1818 6TH AVE

601 Stewart St, 1818 6th Ave, 600 Olive Way
Project #: 3038765-LU

DRB RECOMMENDATION MEETING

DOWNTOWN DESIGN REVIEW BOARD
December 13, 2022

Ground Floor Elevation - 6th Avenue

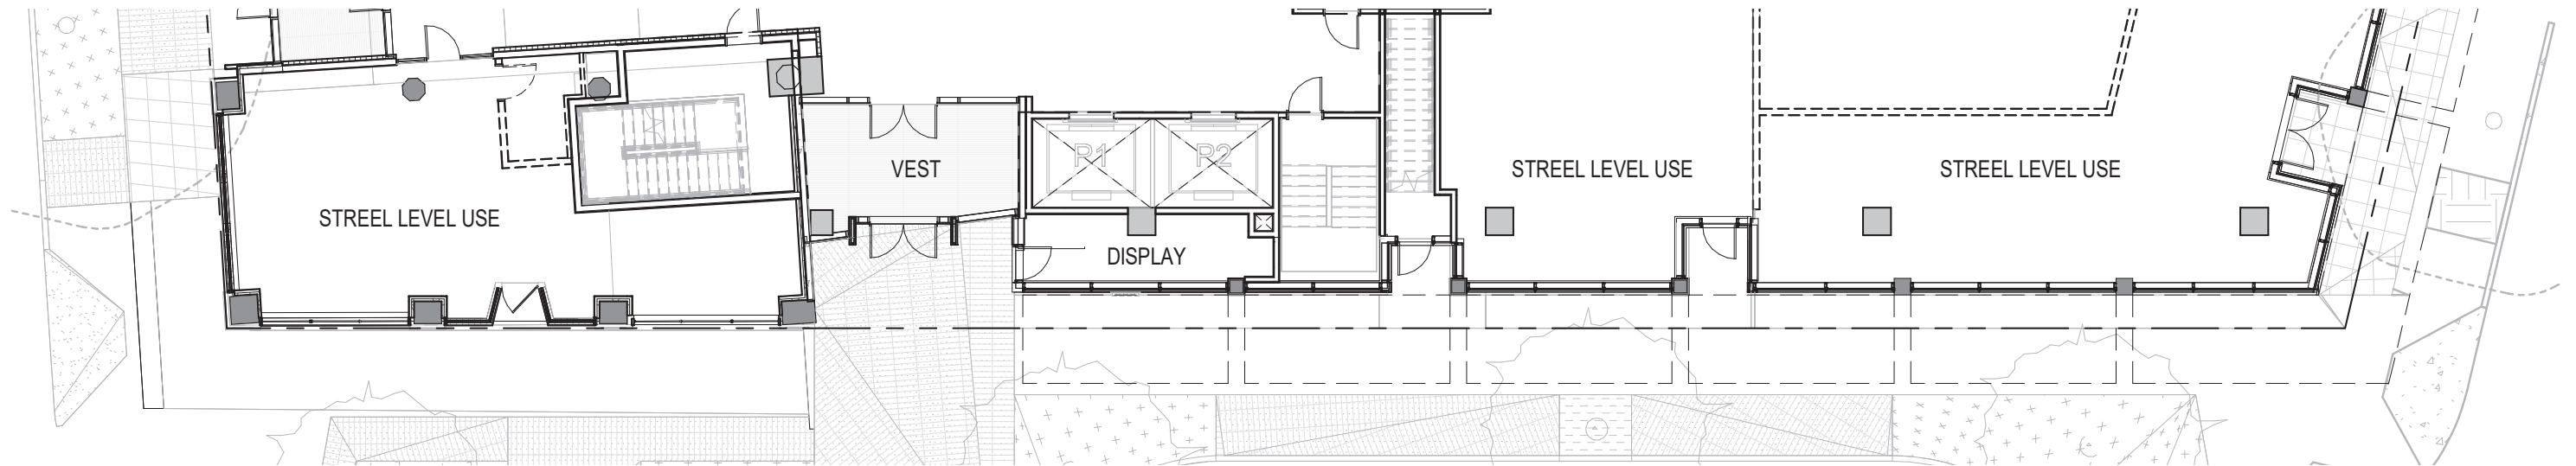
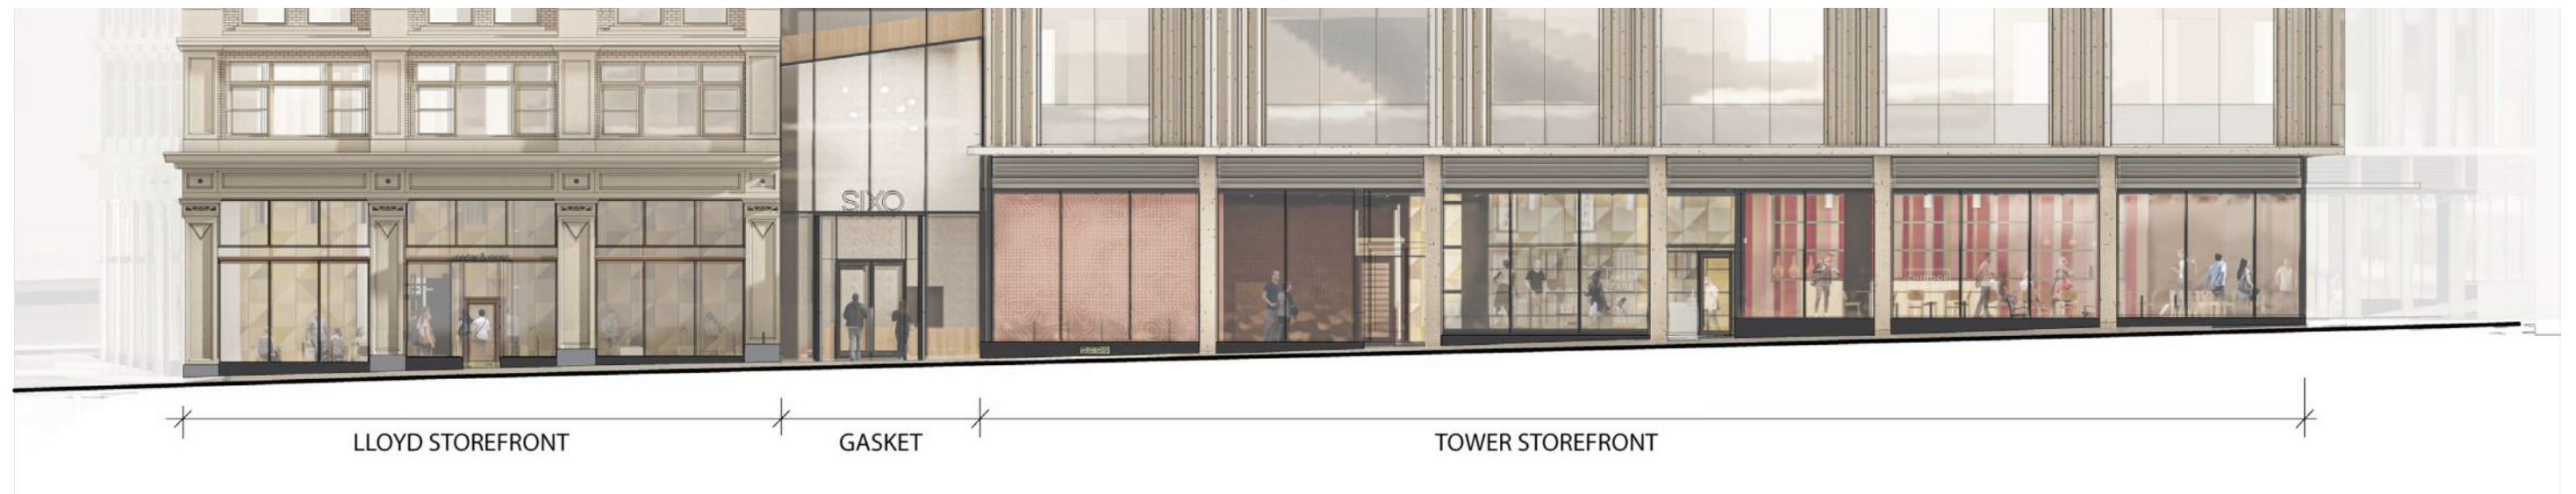
BOARD COMMENT	DESIGN RESPONSE
<p>EDG #1 (1/4/2022) Ground Level Uses & Pedestrian Activation 2b</p> <ul style="list-style-type: none"> The Board appreciated the inclusion of small scale retail at the ground level The Board directed further study of the rhythm, texture, and human scale of the street level façade of the historic Lloyd Building and how these qualities are articulated for pedestrian activity at the street level façade of the new portion of the development. <i>C-1: Promote Pedestrian Interaction and C-1.3: Street Level Articulation for Pedestrian Activity</i> 	<ul style="list-style-type: none"> Lloyd Building storefronts have been further analyzed in terms of rhythm and scale New tower storefronts have been developed to provide a rhythm of retail bays at street level New tower storefronts will be differentiated in materiality and detailing to avoid historic mimicry

Olive Way Facade

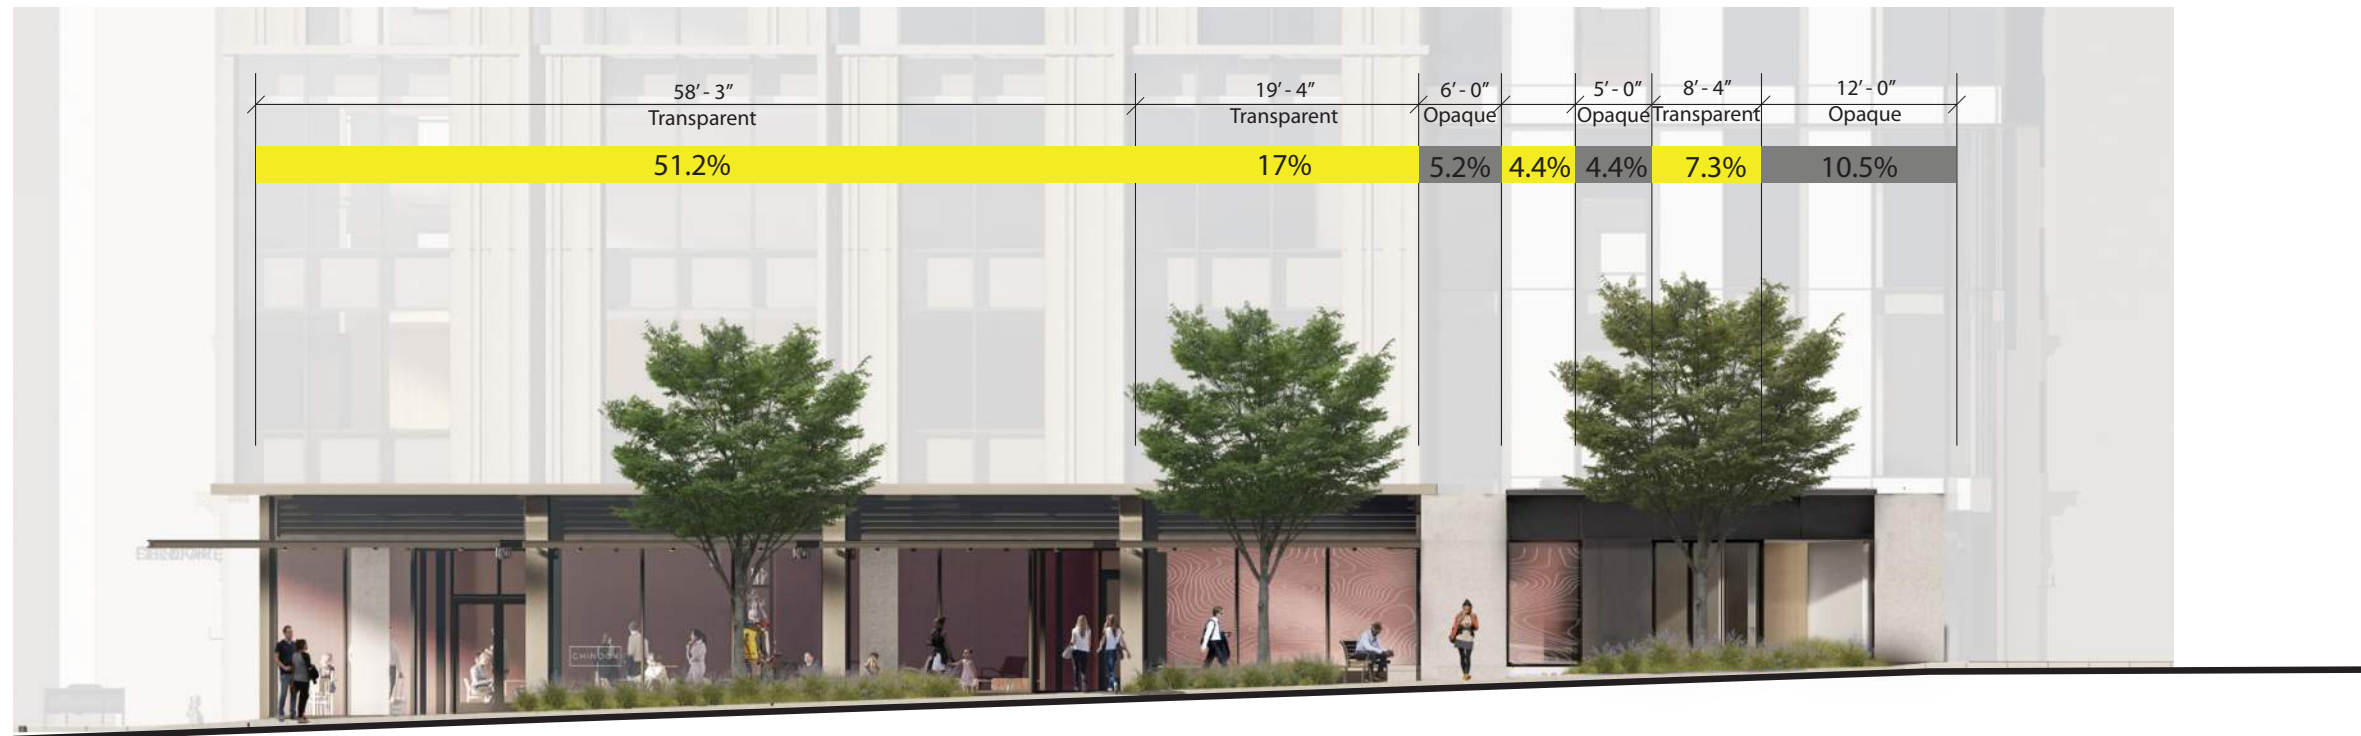
BOARD COMMENT		DESIGN RESPONSE
<p>EDG #1 (1/4/2022) Ground Level Uses & Pedestrian Activation 2c</p>	<ul style="list-style-type: none"> The Board acknowledged the constraints associated with building systems and services that impede the ground level The Board requested further study of relocating the generator and increasing active uses and transparency along Olive Way <i>C-1: Promote Pedestrian Interaction, C-1.1: Street Level Uses, C-3: Provide Active — Not Blank — Facades, and C-3.1: Desirable Facade Elements</i> 	<ul style="list-style-type: none"> Generator room size reduced to allow for a continuous glass display window along Olive Way Active Use requirements are achieved along Olive Way with 51% of frontage dedicated to retail Glass display window increases the total transparency along Olive Way to 80% Studies of alternate locations were conducted, no feasible options resulted in benefits to the public realm (see appendix for detailed studies)

- Located along Olive Way
- Nearly continuous display window to street frontage
- Allows for larger corner retail suite (F&B possible)
- **RECOMMENDED**

DEPARTURE REQUEST 3.A: OVERHEAD WEATHER PROTECTION

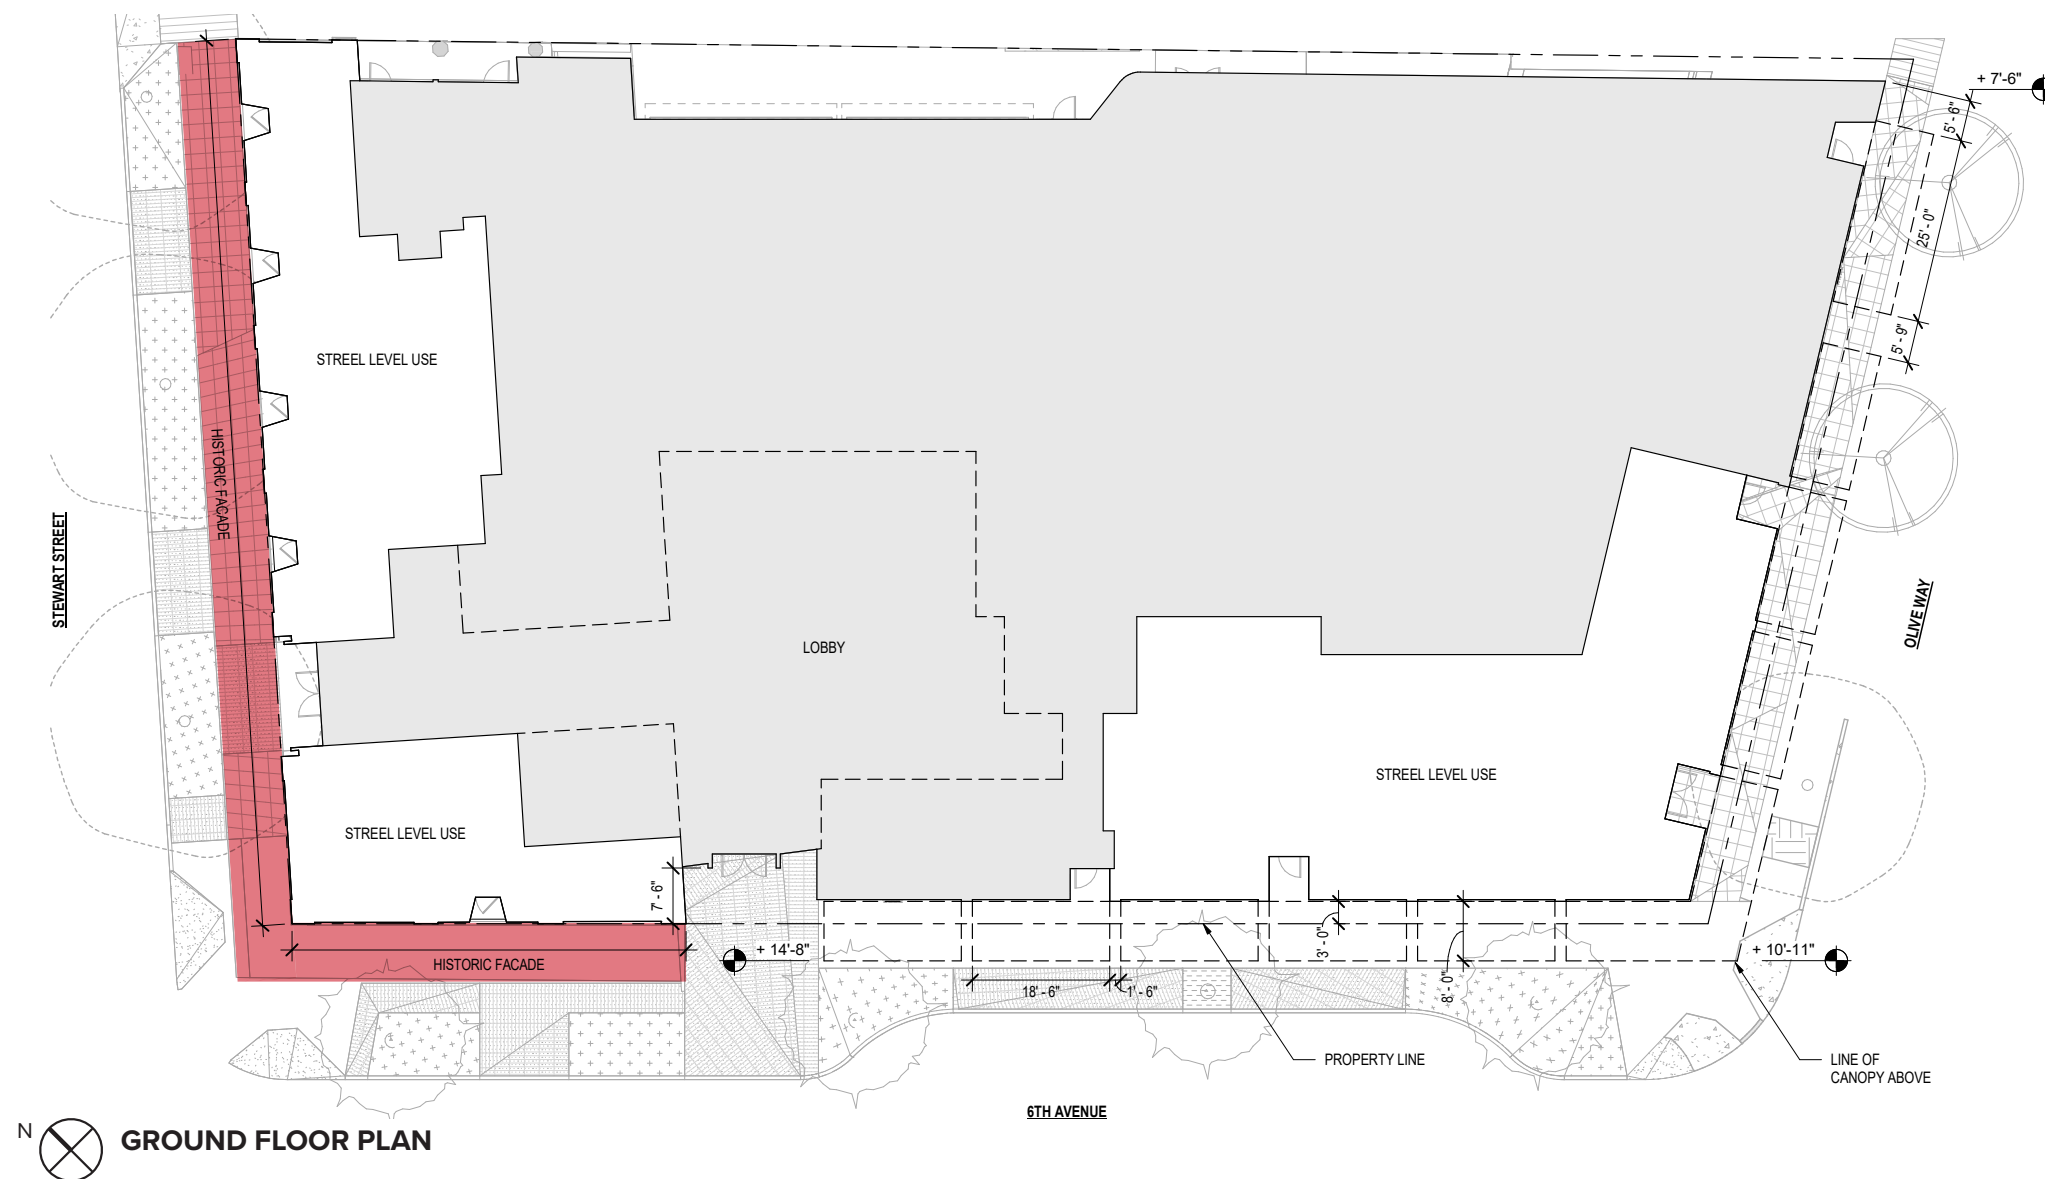
CODE CITATION	REQUIREMENT	DEPARTURE	RATIONALE	DESIGN GUIDELINES
23.49.018 Overhead Weather Protection	23.49.018.A: Continuous overhead weather protection shall be required for new development along the entire street frontage of a lot	No retrofit overhead weather protection applied to the historic Lloyd Building	As a historic landmark, it is not appropriate to add canopies to the Lloyd Building. The Landmarks Preservation Board was in unanimous agreement that adding canopies to the historic building would severely detract from its historic character.	B-3 Reinforce the positive urban form & architectural attributes of the immediate area.

DEPARTURE REQUEST 3.B: OVERHEAD WEATHER PROTECTION

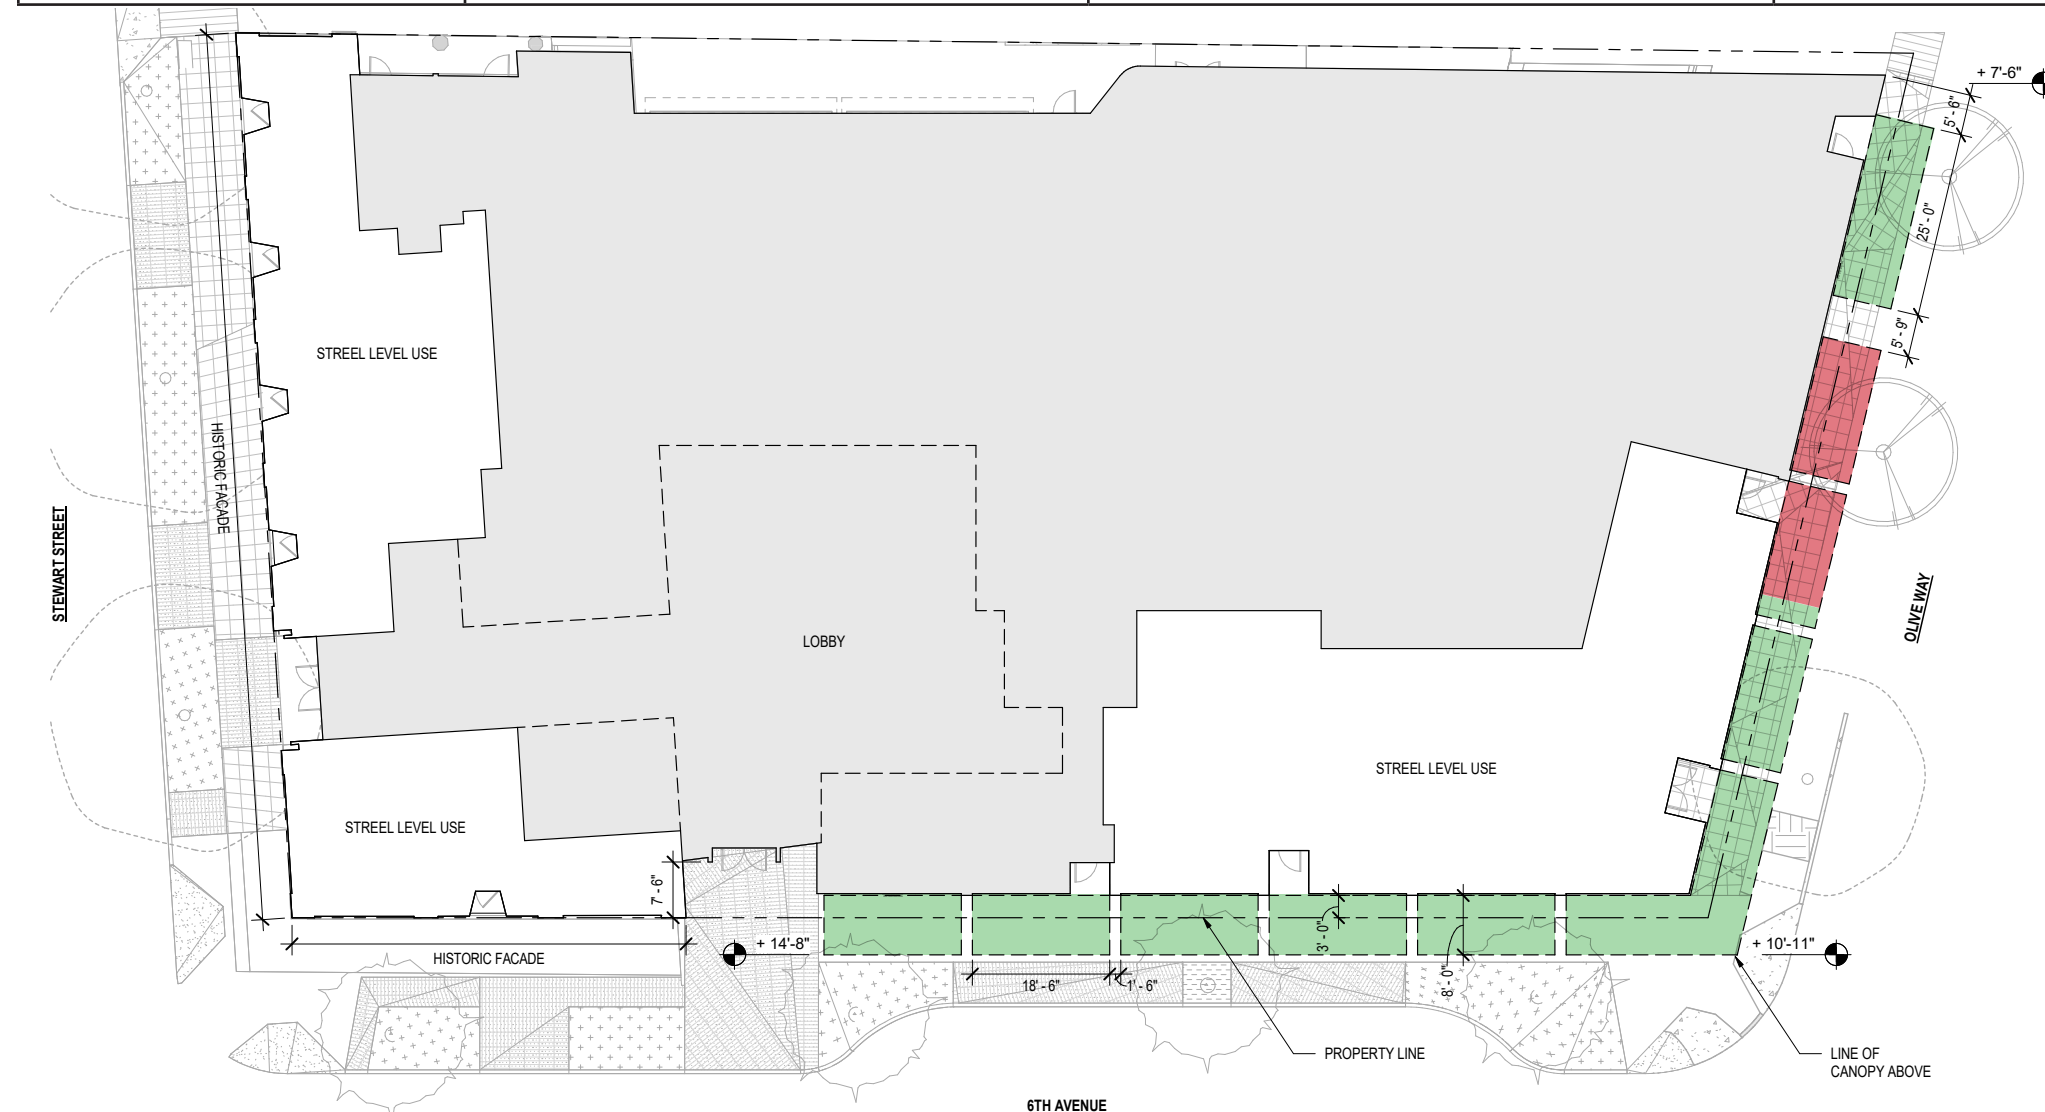
CODE CITATION	REQUIREMENT	DEPARTURE	RATIONALE	DESIGN GUIDELINES
23.49.018 Overhead Weather Protection	23.49.018.D: The lower edge of the overhead weather protection must be a minimum of ten (10) feet and a maximum of fifteen (15) feet above the sidewalk	Less than 10'-0" height from sidewalk as grade slopes up along Olive Way	The canopy datum is established on 6th Ave by a significant relationship to the historic Lloyd Building facade. To create a unified building, this datum continues on Olive Way. The rising sidewalk condition heading east along Olive Way causes a portion of the canopy to be lower than the 10' min. height (proposed canopy is 8'-10" above grade at its lowest point). The design team seeks a departure to allow this portion of the canopy to be max. 1'-2" below the minimum height above the sidewalk.	B-4 Design a well-proportioned & unified building
